Addendum No. 2
To the Plans and Specifications of

Mobile Fire Station #19
1309 Azalea Road
Mobile, Alabama 36693

Four Pages + Attachment(s)
June 26, 2025

P201
SANITARY PLAN

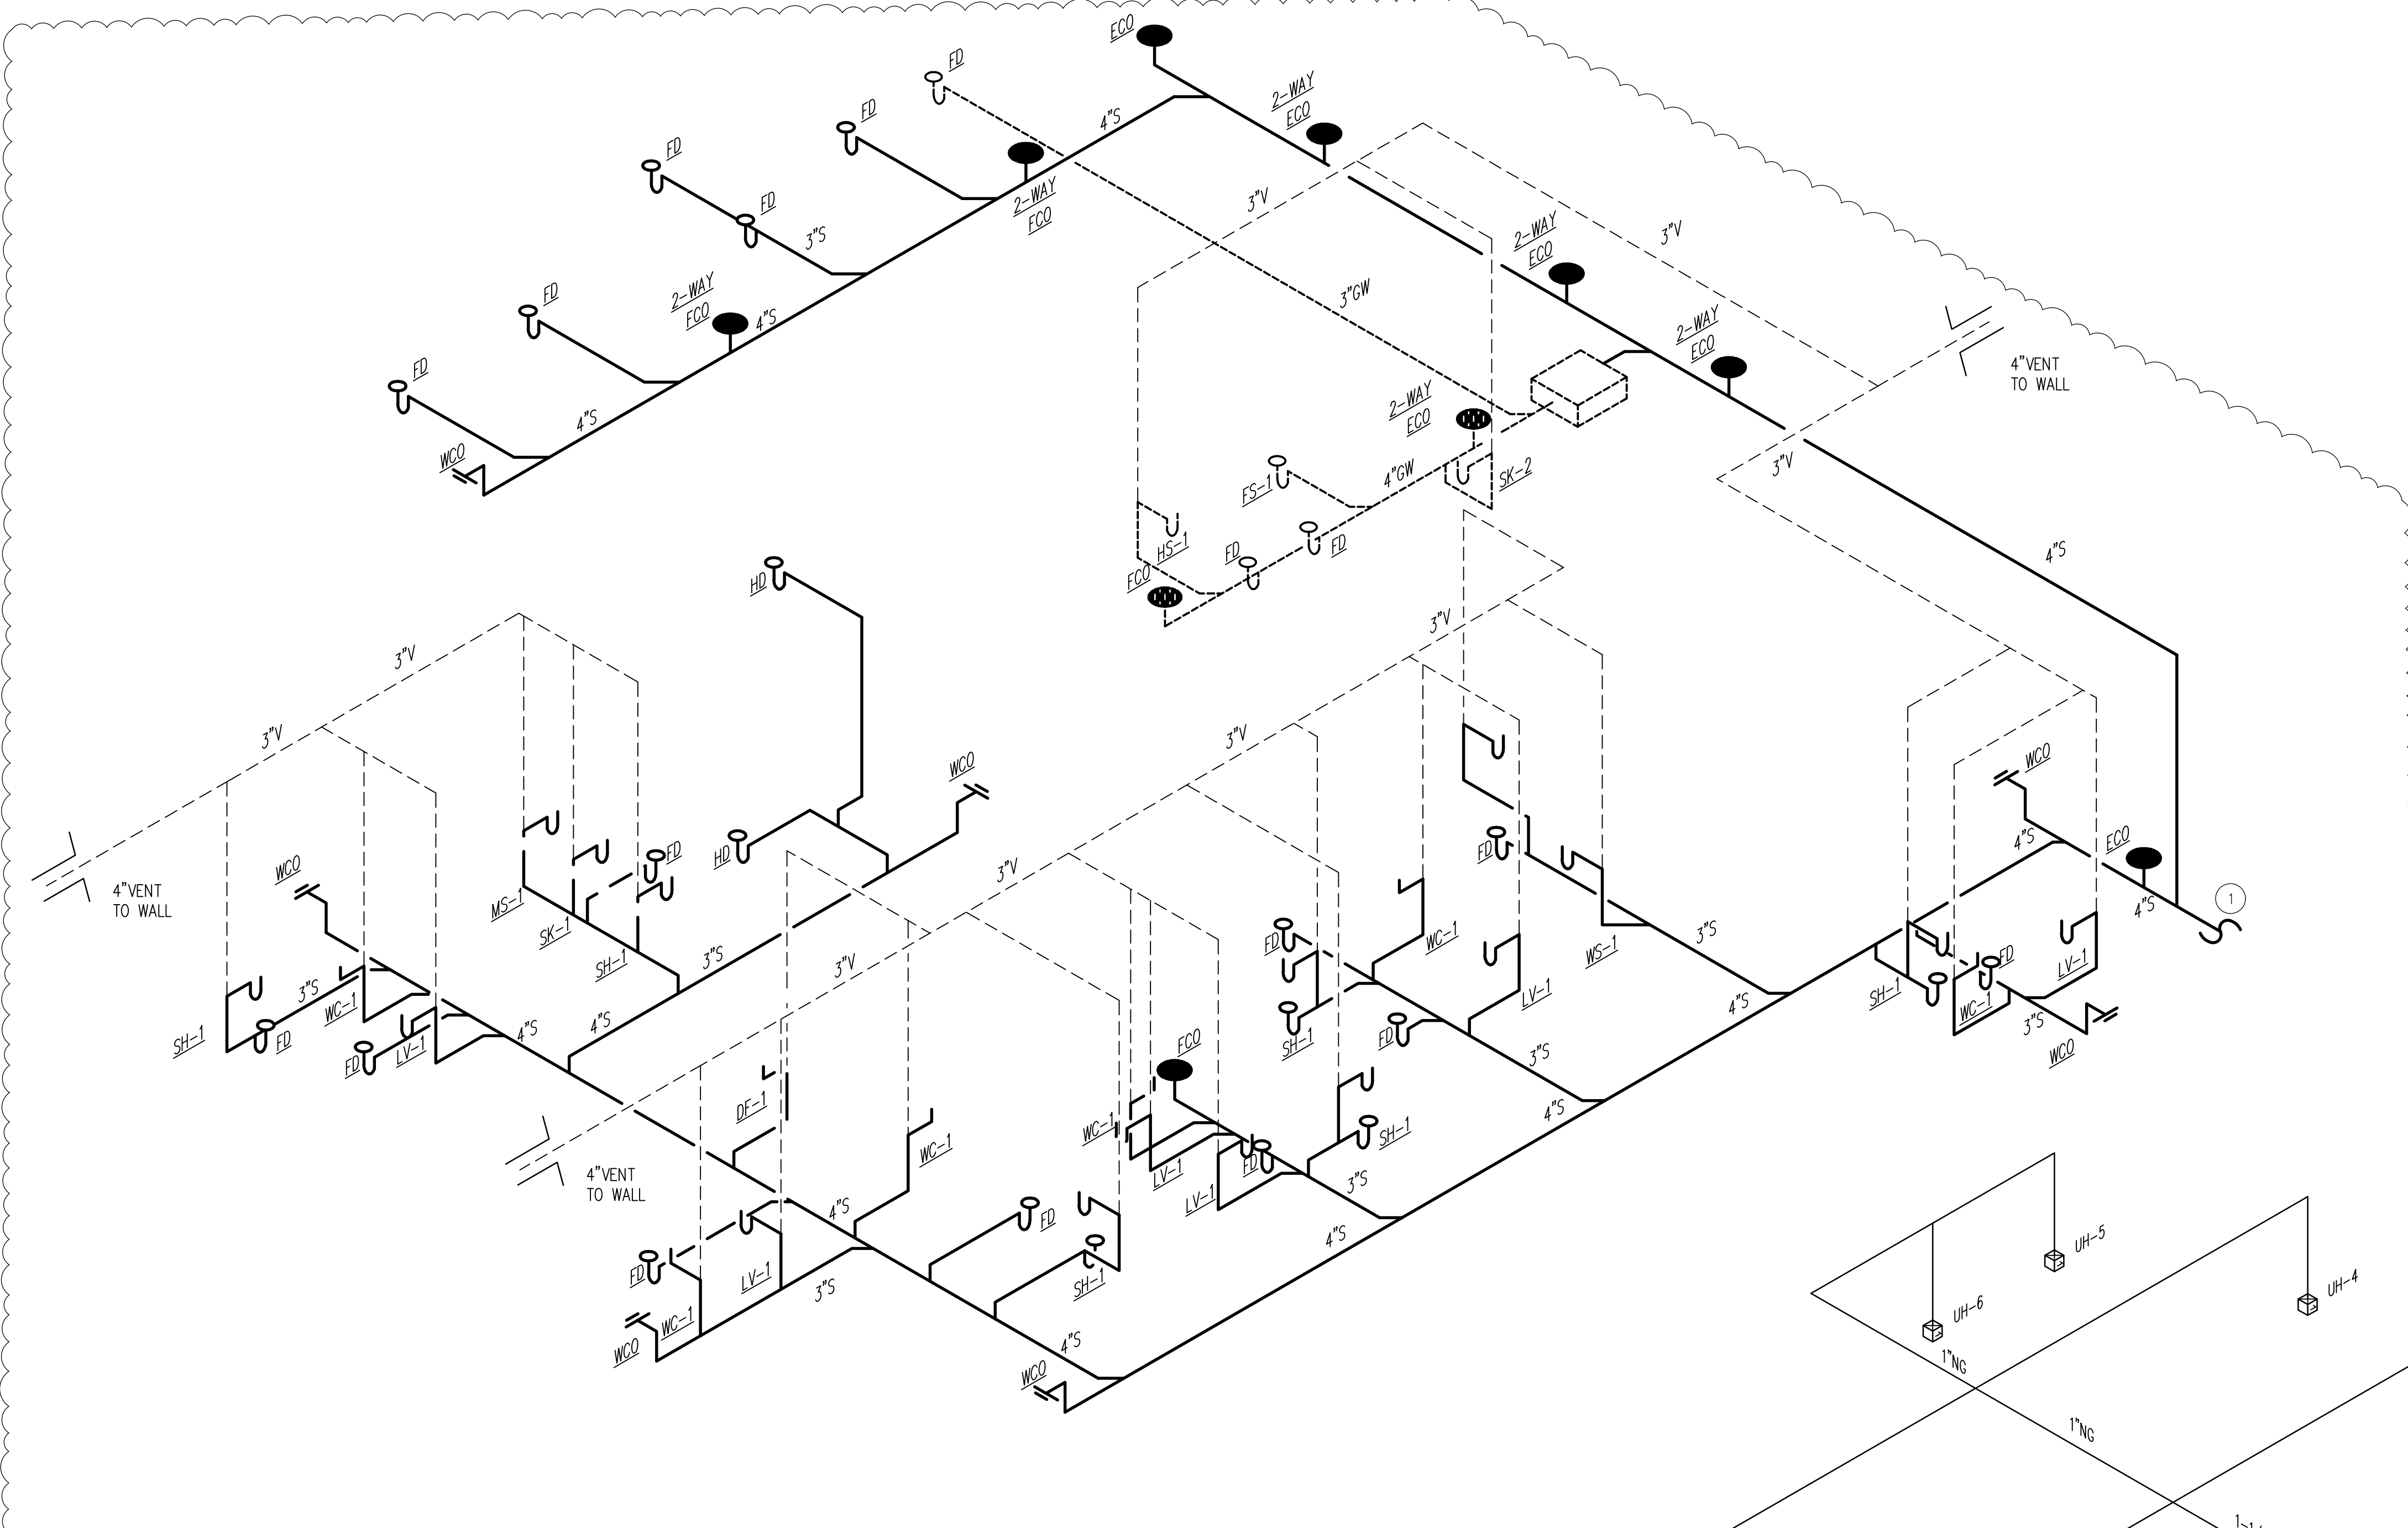
- M7. Sheet P201 – CONNECTED CAN WASH FLOOR DRAIN TO GREASE WASTE SYSTEM. CHANGED FLOOR DRAIN TO FLOOR SINK FOR ICE MACHINE IN KITCHEN. ADDED BRANCH PIPING SIZES FOR SANITARY SYSTEM.

P300
RISER DIAGRAMS

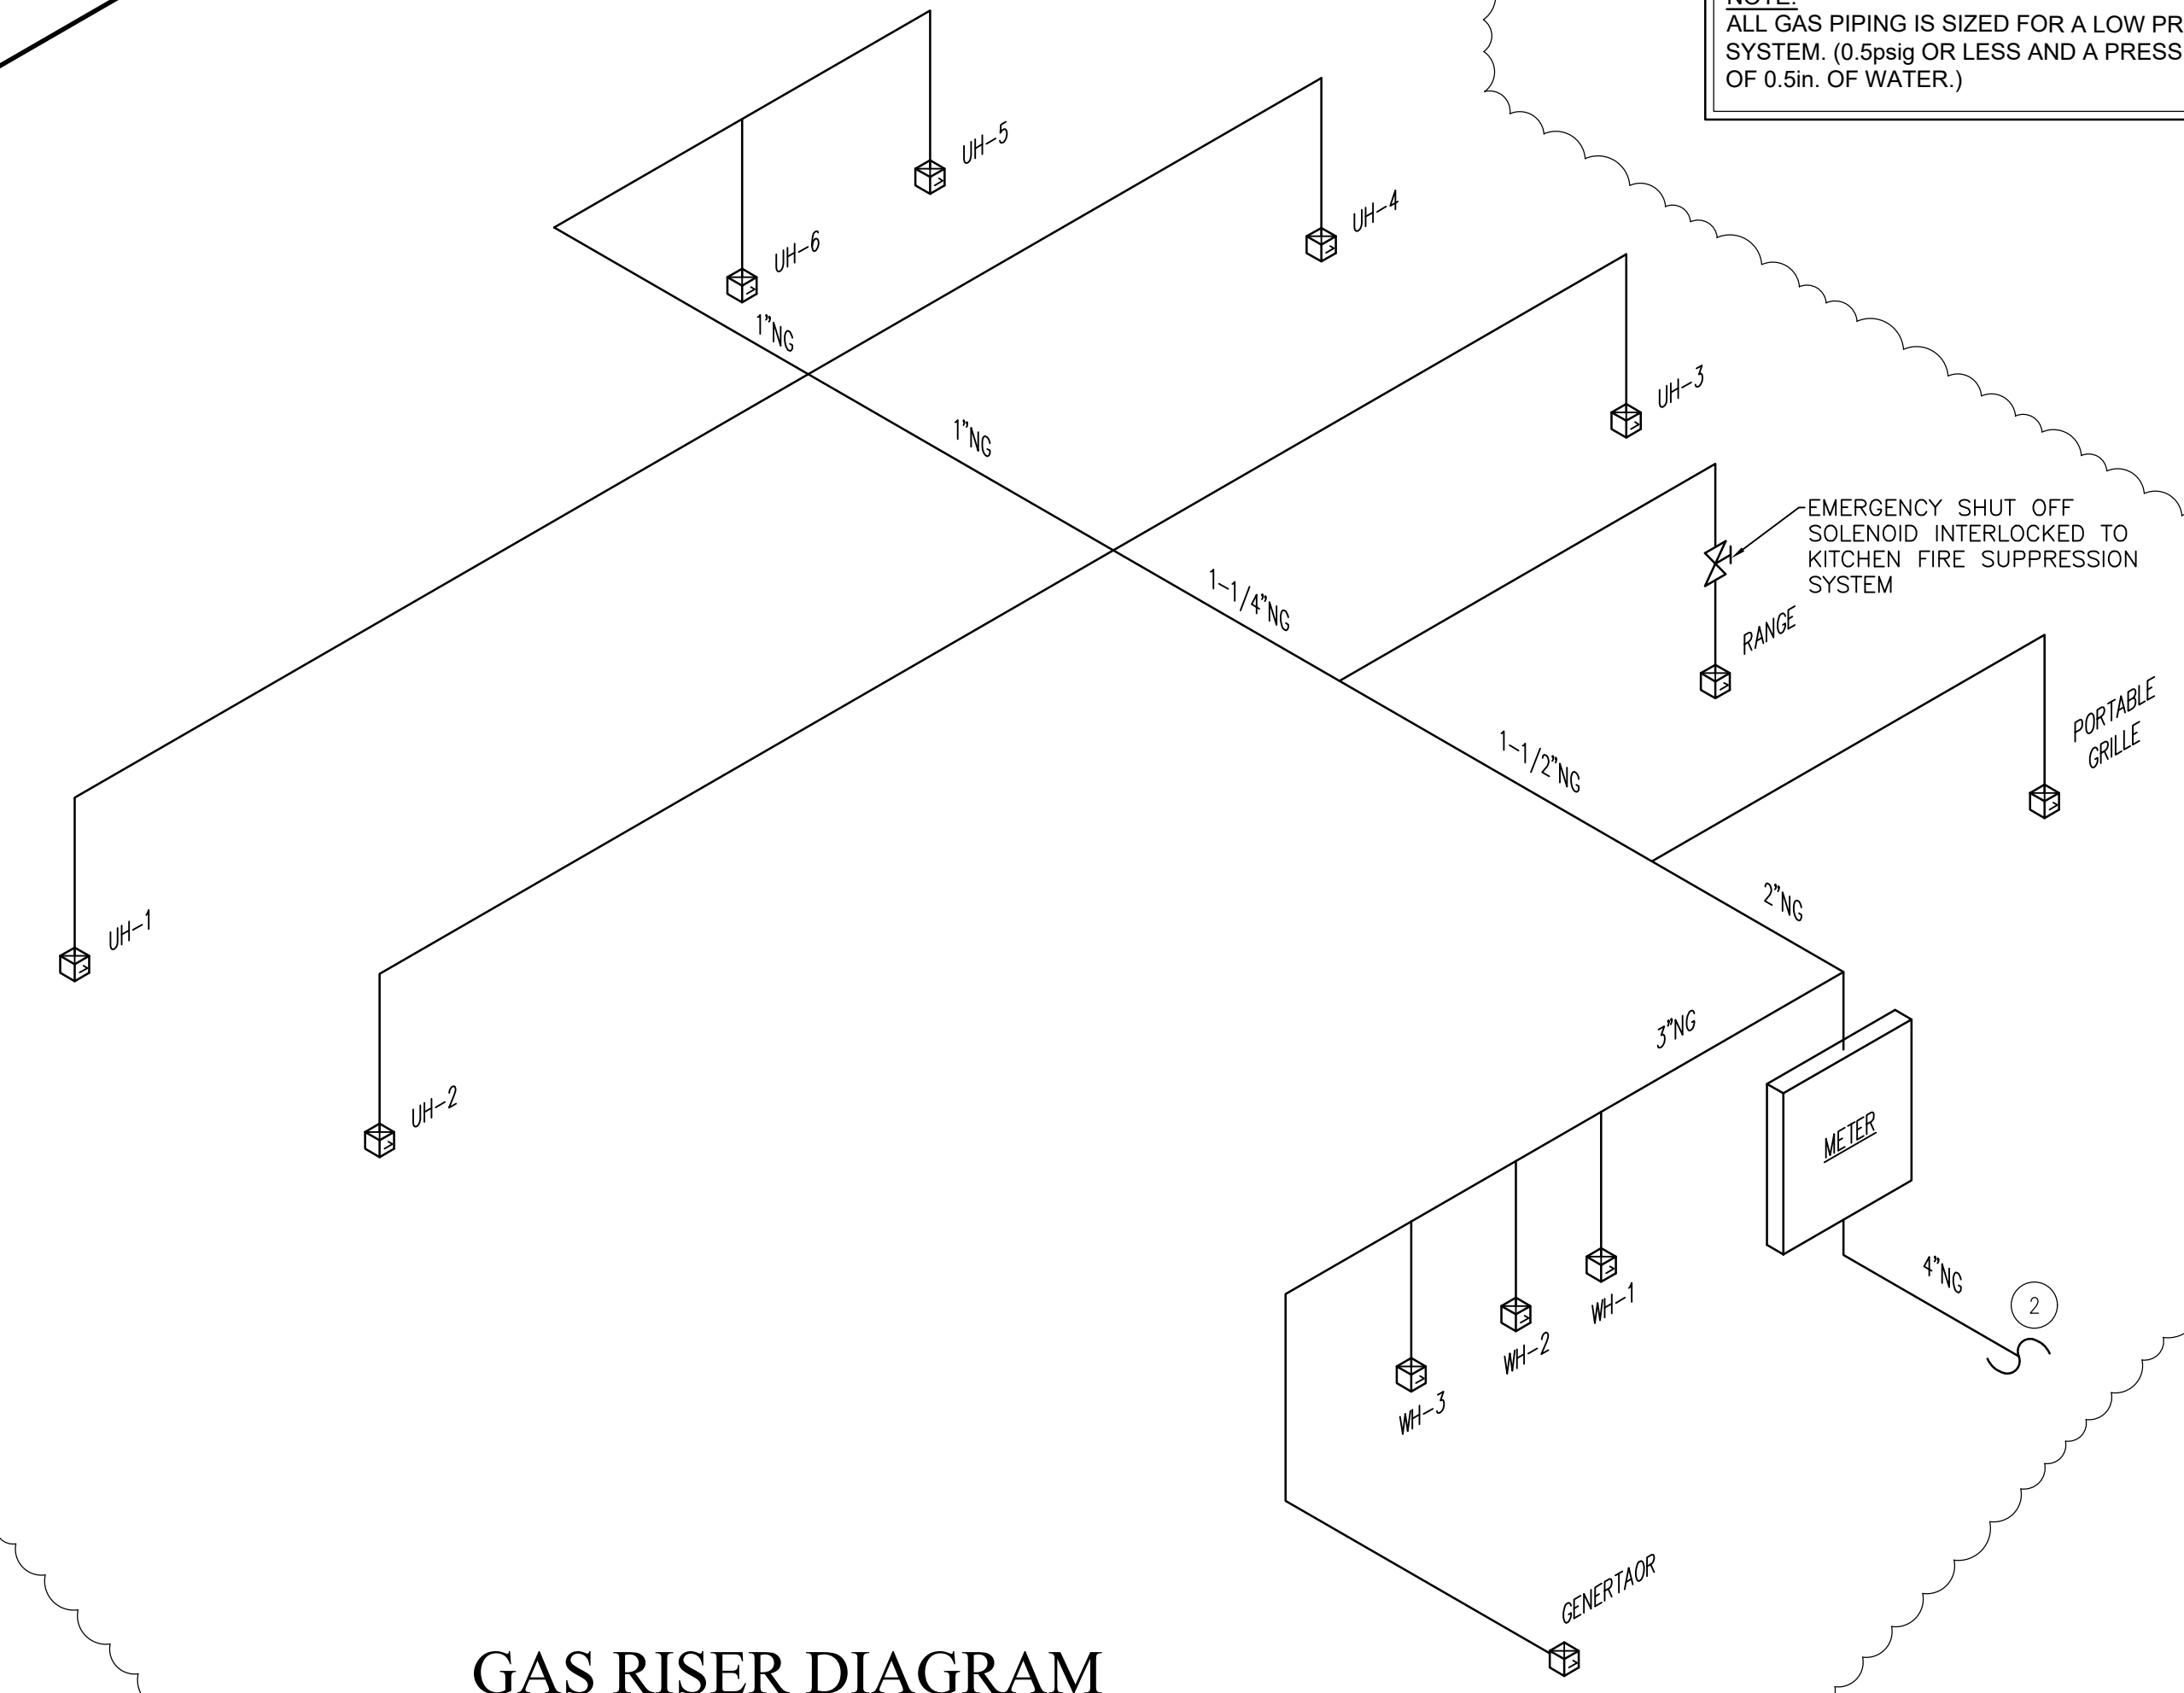
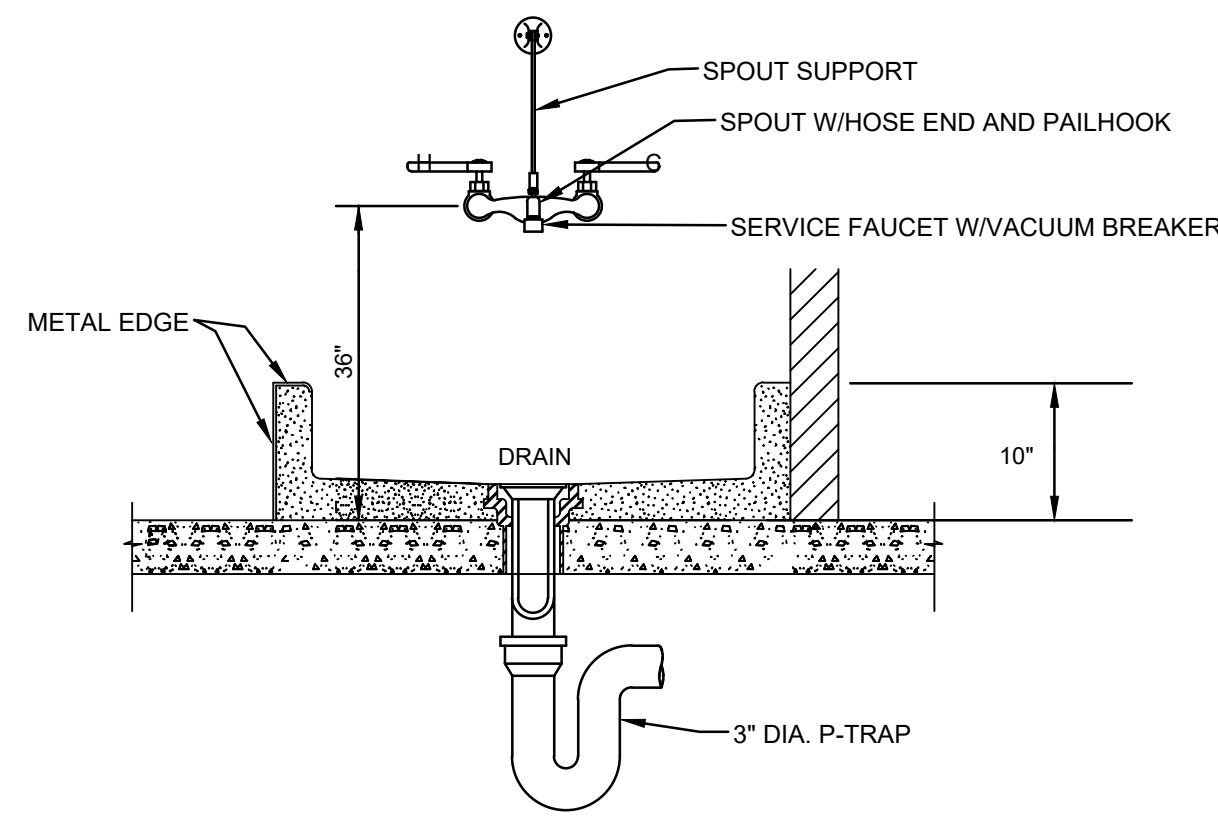
- M8. Sheet P300 – UPDATED SANITARY AND NATURAL GAS RISER DIAGRAMS PER CHANGES. UPDATED KEYNOTE #1.
- M9. Sheet P400 – REMOVED DETAIL 2 FROM SHEET AND REPLACED WITH WATER HAMMER DETAIL.
